PIC16CR63 Rev. A Silicon Errata Sheet

The PIC16CR63 parts you have received conform functionally to the Device Data Sheet (**DS30234D**), except for the anomalies described below.

Clarifications/Corrections to the Data Sheet:

FIGURE 1: WRITES TO TIMER1 (EXTERNAL CLOCK / OSCILLATOR MODE)

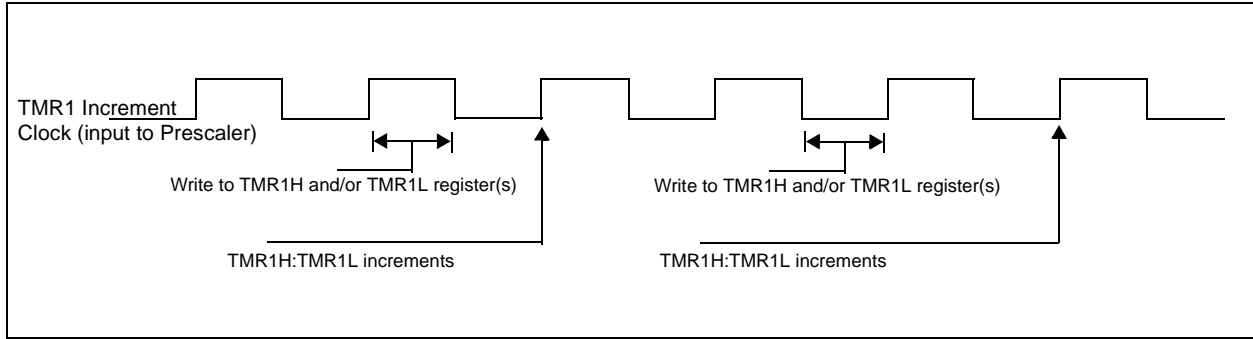
- a) The operation of Timer1 needs some clarification when the timer registers are written when the TMR1ON bit is set.

The internal clock signal that is the input to the TMR1 prescaler affects the incrementing of Timer1 (TMR1H:TMR1L registers and the Timer1 prescaler). When the Timer1 registers are NOT written, the Timer1 will increment on the rising edge of the TMR1 increment clock.

When the TMR1H and/or TMR1L registers are written while this clock is high, TMR1 will increment on the next rising edge of this clock.

When the TMR1H and/or TMR1L registers are written while this clock is low, TMR1 will not increment on the next rising edge of this clock, but must first have a falling clock and then the rising clock for TMR1 to increment.

Figure 1 shows the two cases of writes to the TMR1H and/or TMR1L registers. Due to the V_{IH} and V_{IL} thresholds on the oscillator/clock pins, external Timer1 oscillator components, and external clock frequency, the Timer1 increment clock may not be of a 50% duty cycle.

The TMR1 increment clock is out of phase of the T1OSO/T1CKI pin by a small propagation delay.
